UNITED STATES  
NUCLEAR REGULATORY COMMISSION  
WASHINGTON, D. C. 20555

Docket No: 50-368

FACILITY: Arkansas Nuclear One, Unit 2

SUBJECT: SUMMARY OF MEETING FOR ARKANSAS NUCLEAR ONE AND THE INCIDENT OF SEPTEMBER 16, 1978 REGARDING OVERLOAD CONDITIONS ON STARTUP TRANSFORMER NO. 2 AND THE CONSEQUENT UNIT 2 CONTAINMENT SPRAY

SIMPLIFIED LINE  
DIAGRAM  
AND UNITS I & 2

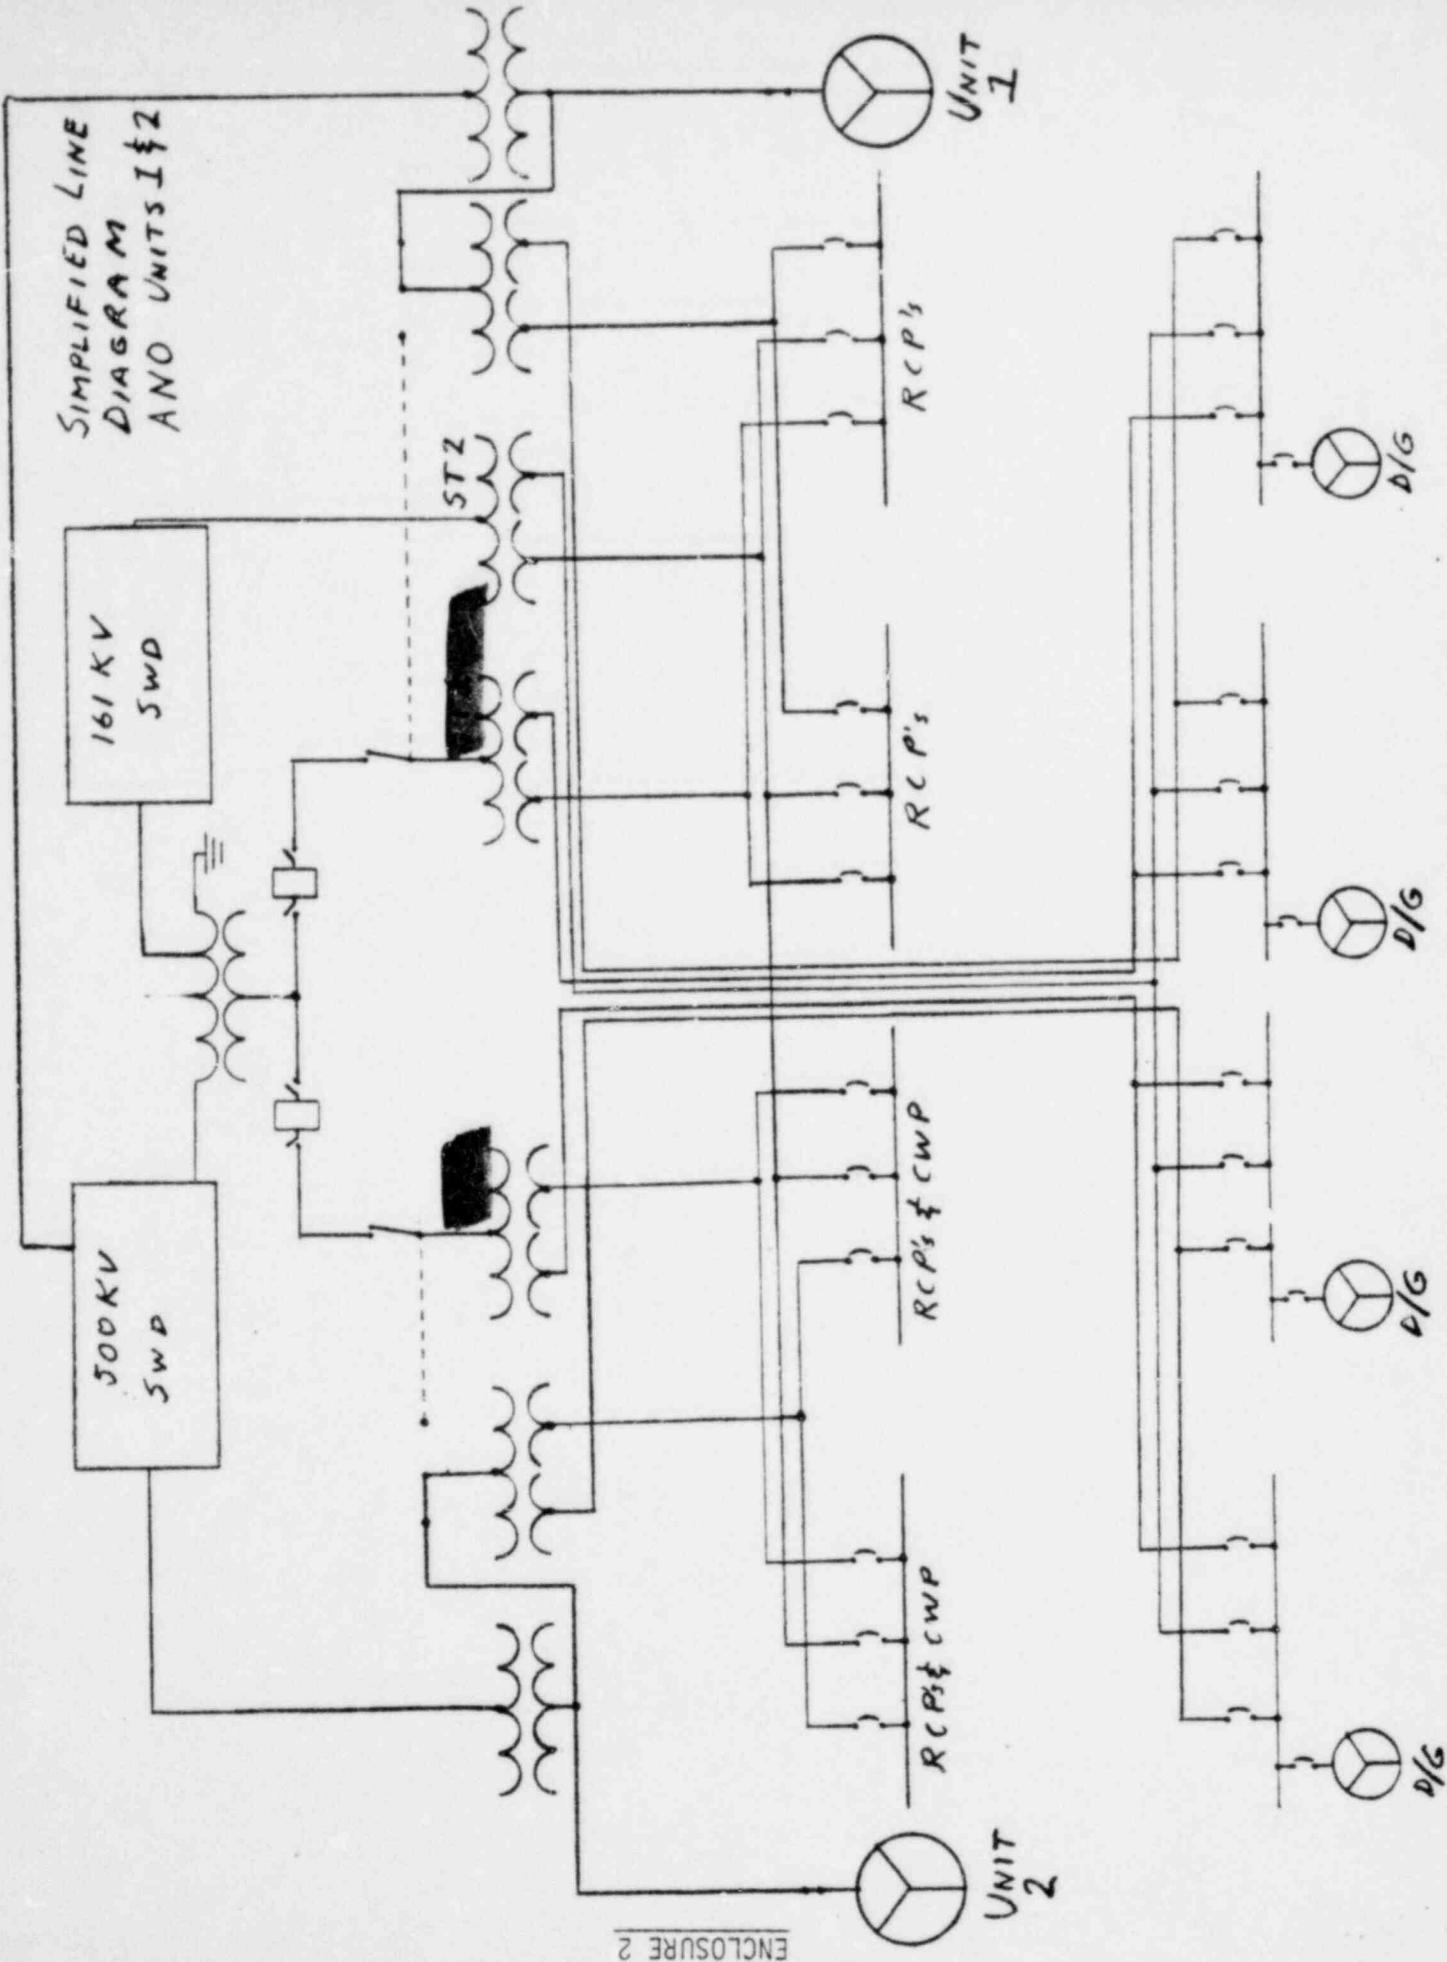
Each of the two units of Arkansas Nuclear One, i.e., Unit 1 and Unit 2, have a dedicated unit auxiliary transformer and a dedicated startup transformer, each of which can supply the necessary alternating - current power to all of the respective unit auxiliaries, including both safety and non-safety loads. The unit auxiliary transformers are supplied from their respective unit generator. The unit startup transformers are both supplied through a single auto-transformer which is linked to the 500 kilovolt and 161 kilovolt sections of the station switchyard (See Enclosure 2).

When both units are being supplied by their respective startup transformers and the common source of power (the autotransformer) for the startup transformers is lost for any reason, then the auxiliary loads of both units will be automatically transferred to Startup Transformer No. 2. This automatic transfer will overload Startup Transformer No. 2 (exceeding the MVA rating) and also produce an excess voltage drop resulting in a degraded grid voltage condition at the safety and non-safety buses of both units.

With the existing design, the overloading of Startup Transformer No. 2 will result automatically on the failure of the autotransformer circuit feeding the two dedicated startup transformers when the failure occurs concurrently with the following events; (1) both units in either the startup or shutdown modes of operation, (2) trip of one unit while the other unit is in either the startup or shutdown mode of operation, and (3) simultaneous trip of both units.

The design feature of automatic load transfer to startup transformer No. 2 as provided in the Arkansas Nuclear One design, provides a second immediate access circuit which exceeds GDC 17 requirements; however, the resulting overload of startup transformer No. 2 violates the independence requirements of GDC 17.
